# System Impact Assessment Report

**Project:** *Woodstock East TS*

**Applicant:** Hydro One Networks Inc.

*CAA ID 2008-298*

Figure 1. Proposed Woodstock Area Transmission Reinforcement

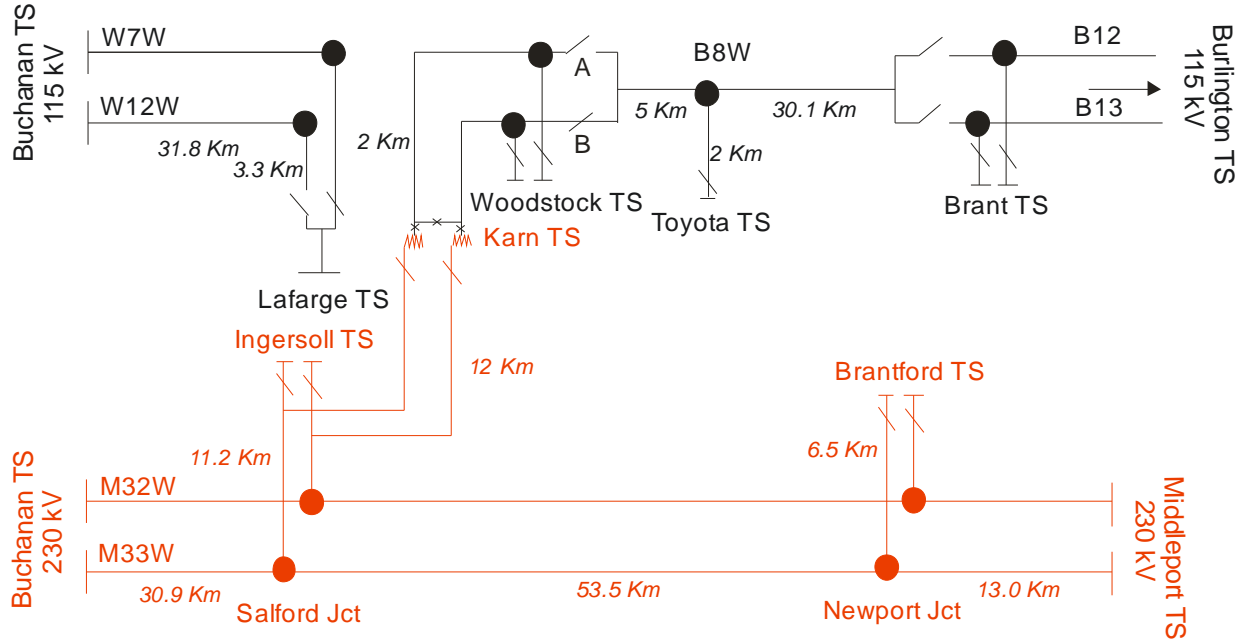
The existing 115 kV disconnect switches at Woodstock TS, 10L7-B8W and 10L12-B8W, allow W7W or W12W to be connected to B8W. With the rebuild of B8W to a double circuit line, these two switches, Labeled “A” and “B” in Figure 1, will be removed.

Figure 3. Single Line Diagram for Woodstock East TS

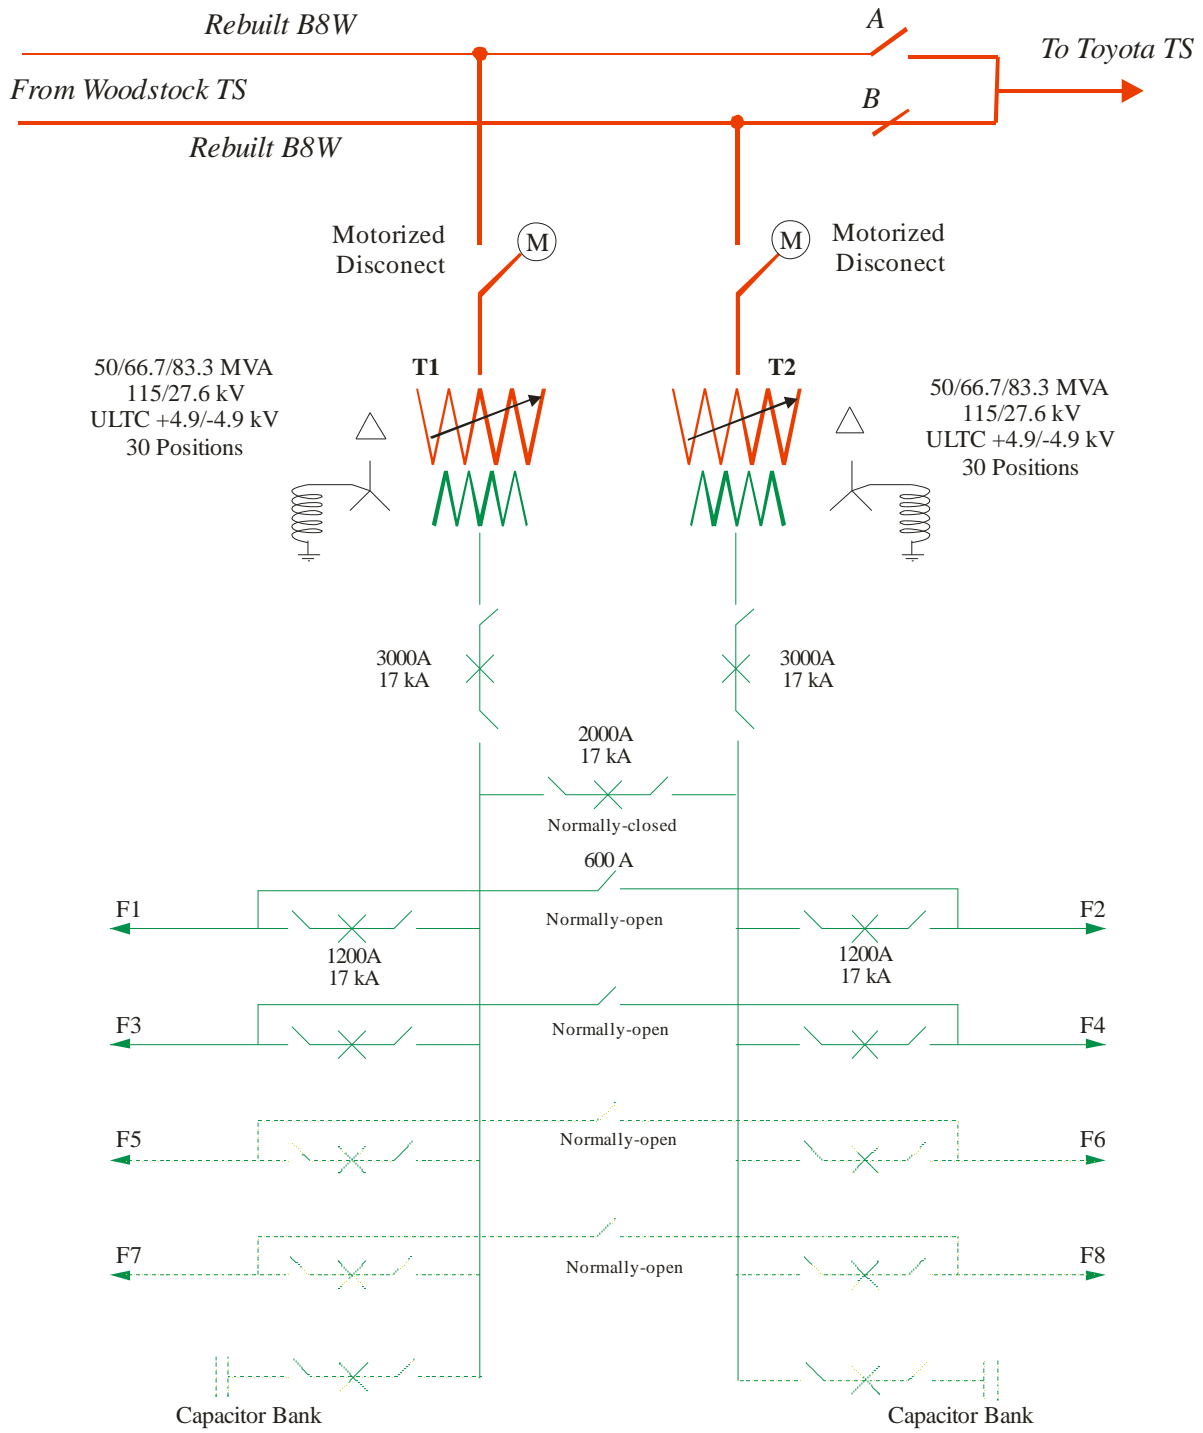
The diagram that was provided by the applicant shows each transformer being separated from the transmission system via a motorized disconnection switch. For this particular arrangement the Transmission System Code requires that transfer trip of the Transmitter's breakers at the terminal stations be provided for transformer faults or for a condition of failure to operate of the 115 kV breakers. In the case of Woodstock East TS, which is to be connected to the double circuit 115 kV lines B8W the transfer trip must be sent to Karn TS terminals of the faulted circuit.

Similar to the existing in-line switches, 10L7-B8W and 10L12-B8W, at the Woodstock TS, two motor-operated disconnect switches, suitable for 230 kV operation, are to be installed between the rebuilt B8W two-circuit line and the existing single circuit B8W. These switches having continuous rating of 1200 A are labeled “A” and “B” in Figures 3.

Hydro One did not provide maximum continuous voltage for the 230 kV disconnect switches in the SIA applications. It should be noted that all 230 kV connection equipment must be capable of continuously operating in the ranges of 220 kV and 250 kV (Reference 2 of Appendix 4.1 of the Market Rules).

The connection applicant is required to provide disconnect switch parameters and ensure that the performance of the equipment that is eventually installed meets or exceeds Market Rule requirements, i.e., the 230 kV disconnect switches must be capable of continuously operating in the range 220 kV and 250 kV.
